Re: Duran Station
4201 Menaul Blvd. NE
Approval of Permanent Certificate of Occupancy (C.O.)
Engineer's Stamp dated 10/27/2004 (H-17/D101)
Certification dated 11/15/2005

**Re: Duran Station, 4201 Menaul Blvd NE, Grading and Drainage Plan
Engineer's Stamp dated 10-27-04 (H17-D101)**

Re: **Duran Station, 4201 Menaul Blvd NE, Traffic Circulation Layout**
Architect's Stamp dated 10-27-04 (H17-D101)

Re: Robbs Ribbs, Grading and Drainage Plan
Engineer's Stamp dated 9-15-03 (H17/D101)

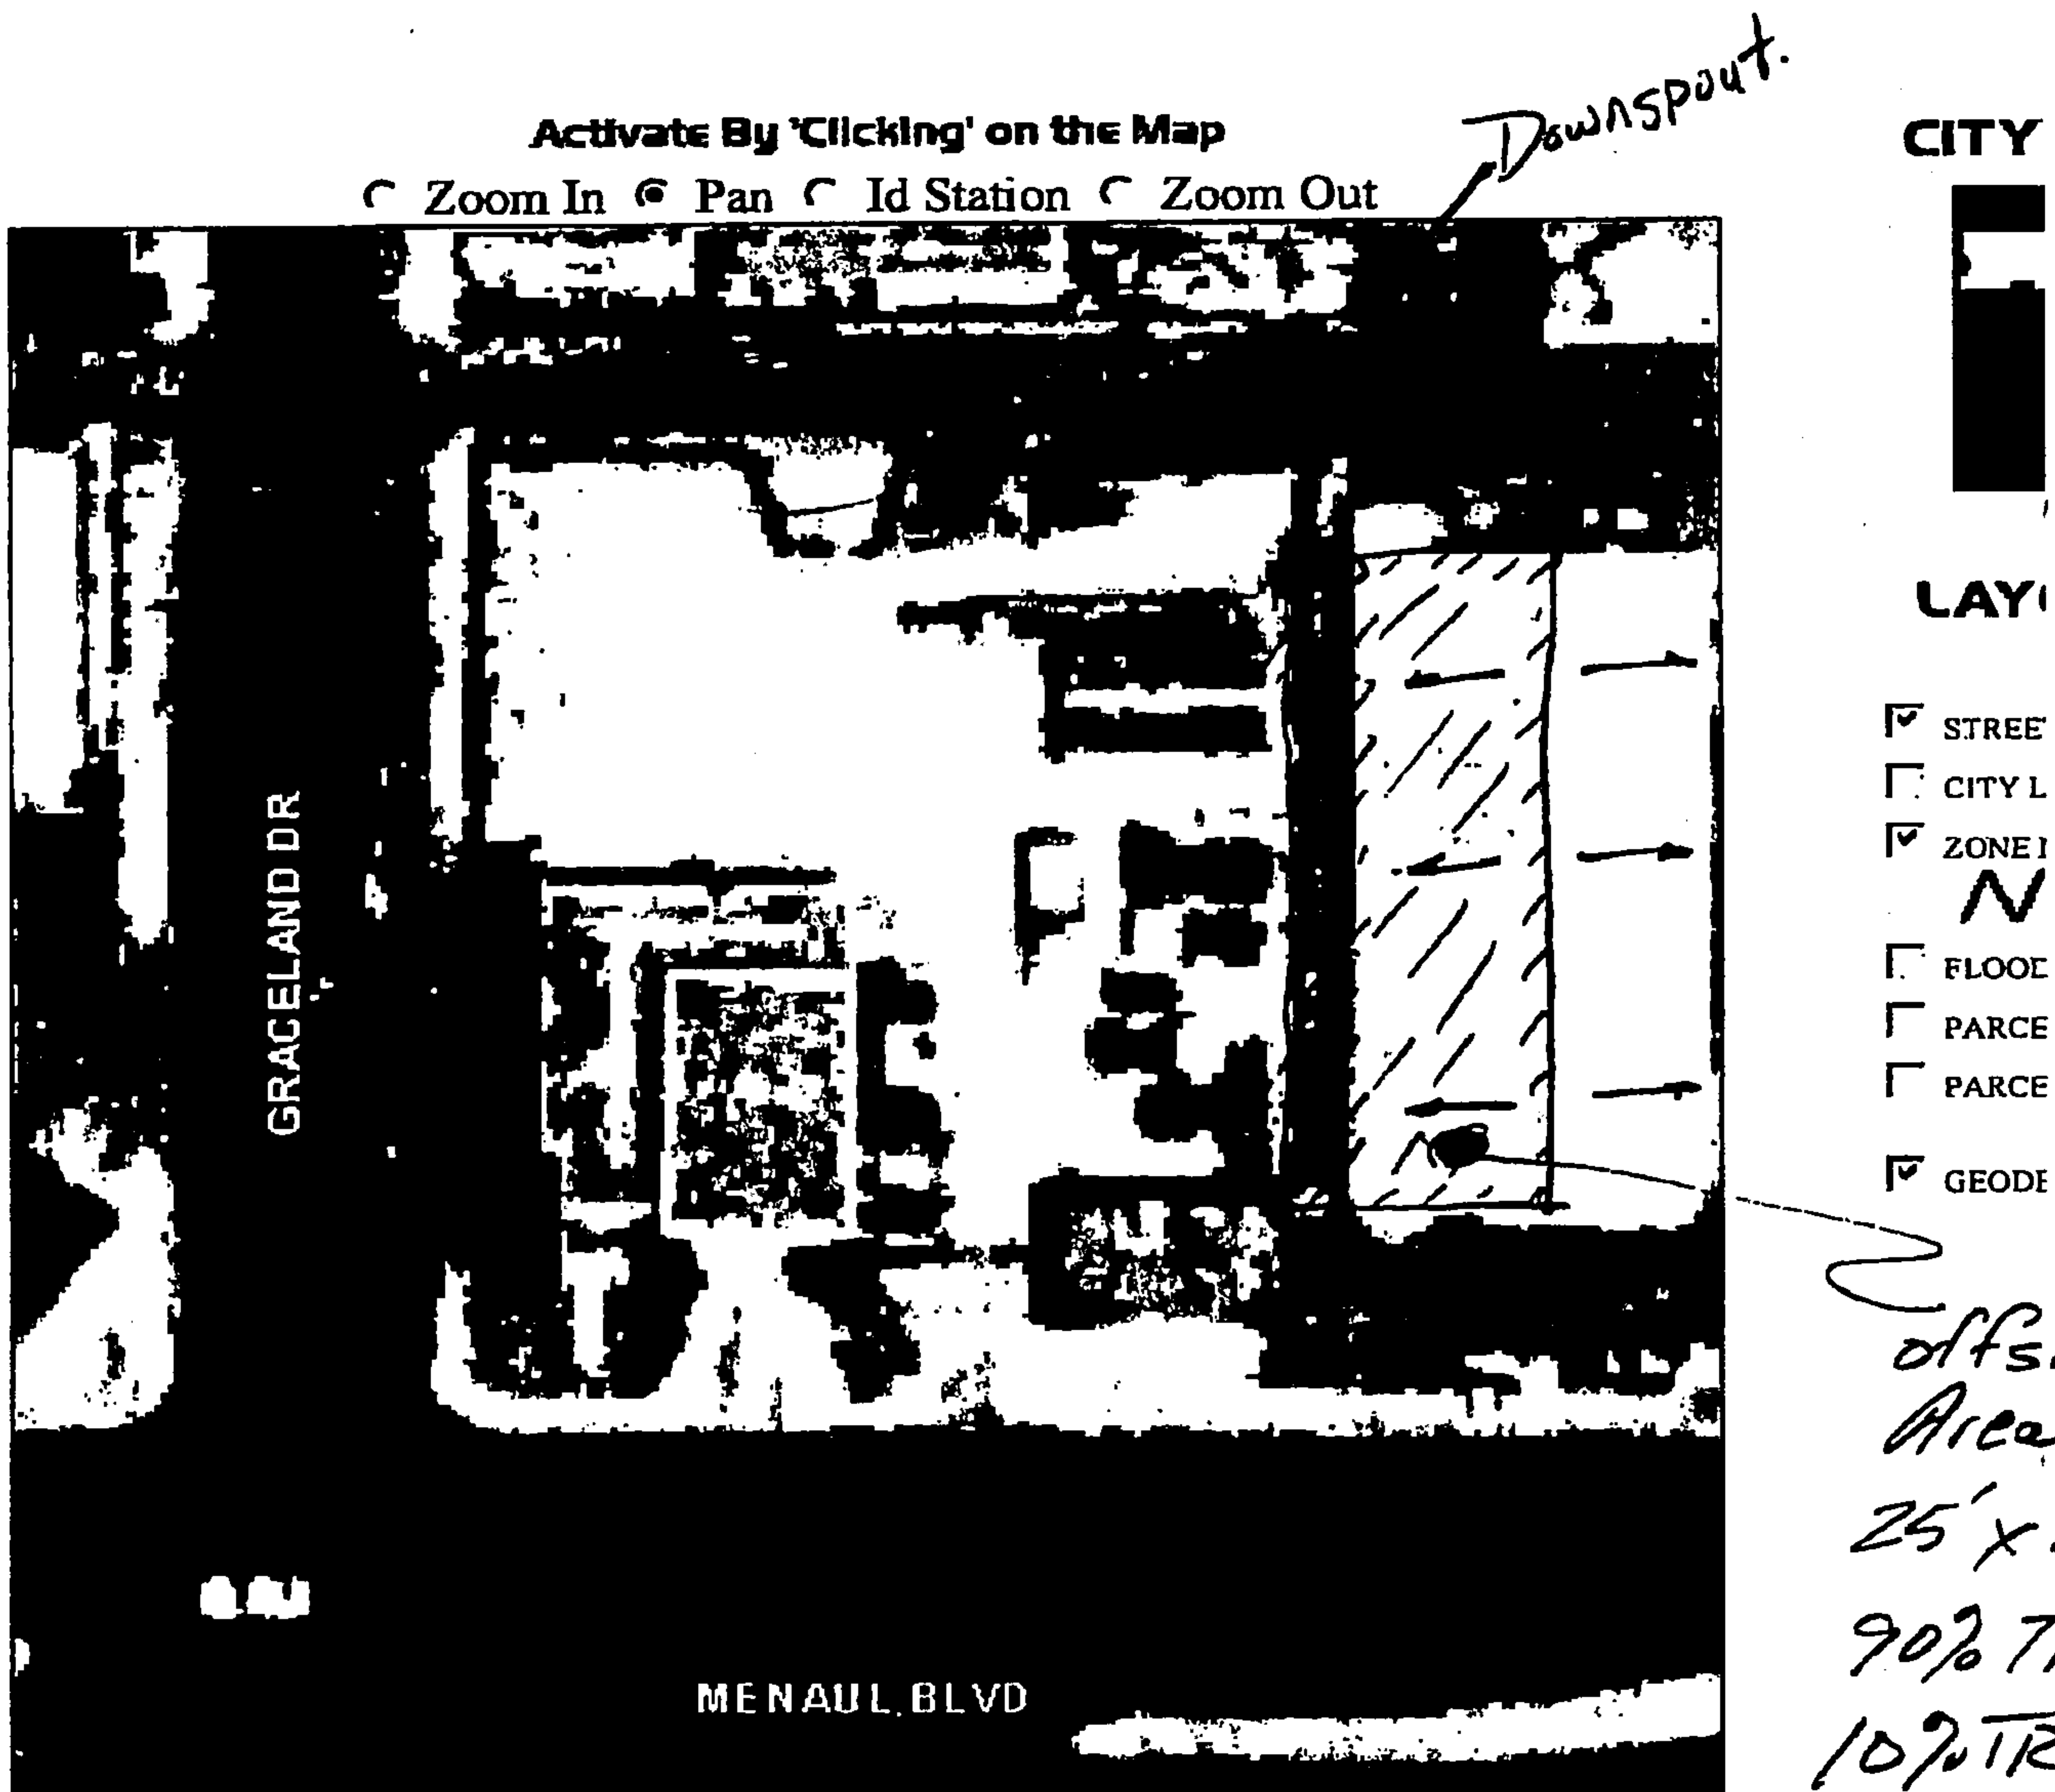
Vicinity Map

Aisle Widths - esp at refuse bin

15' min Radius

Median in Menaul

Nearest drive on adj lot

Menaul -  prim arterial, may not
allow new entrance

Show typ parking sections
— check lengths

Width of sidewalks

ADA applic ramps req at
entrance & exit

Call out City Stds

do sidewalks flush, or raised?

Check if SW culvert will conflict
w/ ADA Ramp

do there are ADA Ramps at corner of
Graceland/Menaul?

Existing conditions at site?
